Tooley Street	Observations	Actions/Comments
 	<p>Marshalling seen to be very effective stopping cyclists in advance of the Cotton Lane crossing at the new “SLOW” road marking.</p> <p>This was beneficial to allow crossing to clear of slow moving pedestrians before cyclists released (on Green).</p> <p>Suggest “Stop/Go” sign provided to forward Marshall to support the “red light” or when crossing congested.</p> 	
  	<p>Marshalls seen to be doing an exemplary job at all times, and to be complimented.</p> <p>One marshal “slowing” or “stopping” cyclists in advance of crossing. Two at the crossing (PM peak) to support the “Red Man”. Marshalls regularly pressing “Wait” once lights go Green aspect to reduce pavement crowding.</p> <p>Suggestion: Current layout needs four marshals, with 3 one side, one the other, at busy PM times.</p> <p>Suggestion: Marshals to have whistles to alert other marshals of imminent danger (e.g fast approaching cyclist, or dashing pedestrian)</p>

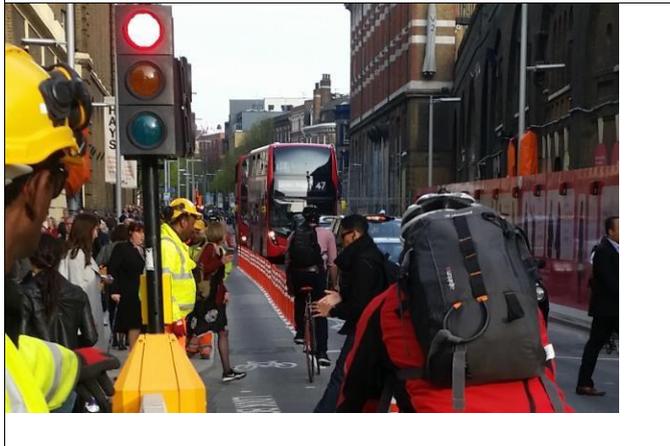
Tooley Street	Observations	Actions/Comments
<p>Cotton Street Crossing</p> 	<ul style="list-style-type: none"> • “Red Man” signage often not clearly visible and obscured by traffic (ringed red in photo). • No clear “<i>warning cyclists</i>” signs for pedestrians. • Pedestrians crossing Northbound are at risk of not seeing/appreciating cyclists. <p>Suggestion: Additional traffic pole signal on each side of crossing for “Red Man”, and provide nearside repeater signal low level for “Red Man”, e.g</p> 	
	<p>Only one “WAIT” button to press on the wrong side for pedestrian flow/desire line (going to the station).</p> <p>When no Marshalls present, the “WAIT” button was regularly not being used by general public, and meant greater informal crossing incidents seen. Pedestrian sensors ineffective.</p> <p>Suggestion: Additional “WAIT” button/module to be installed on the desire line side of the crossing or sensor located to desire line side.</p>

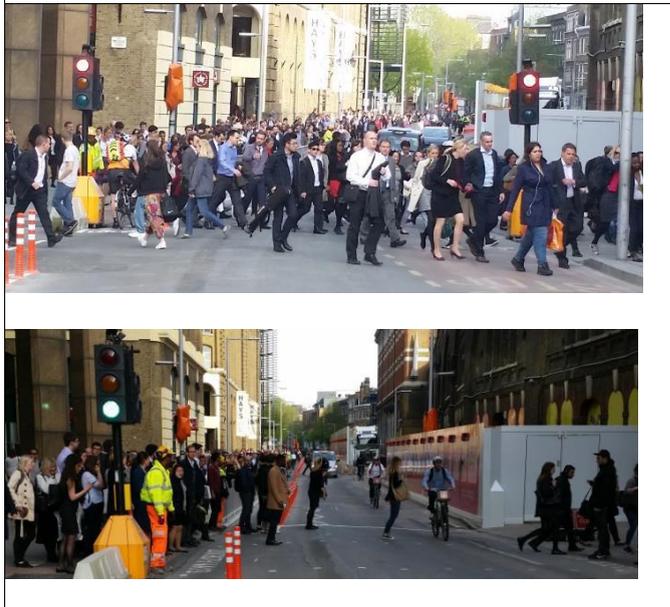
Tooley Street	Observations	Actions/Comments
<p>Pelican Crossing: Puffin Crossing:</p>  	<p>Two pedestrians crossing designs not consistent on Tooley Street in function nor phasing.</p> <p>Joiners Street crossing phase (left photo) is Pelican, and about: 11s Red, 50s Green, and goes “beep beep beep”, with yellow flashing signal.</p> <p>Cotton Lane crossing phase is Puffin and is: 20s Red, about 13s Green (if the WAIT is pressed)</p> <p><i>“Puffins do not have a flashing green man for pedestrians or a flashing amber for drivers.”</i></p> <p>Suggest the Joiners Street Crossing revised to have same timing phase as Cotton lane. This will mean more cyclists become bunched up, and slower on approach to Cotton Lane.</p> <p>Suggest Cotton Lane crossing has flashing Amber stage and beeps.</p>	
	<p>Cotton Lane traffic signal location obscures seeing cycle track (for Eastbound cyclists).</p> <p>The “red and green figures above the control box” appears not to be working. See photo left.</p> <p>Cycle track to be made more visible. Suggest paint blue.</p>
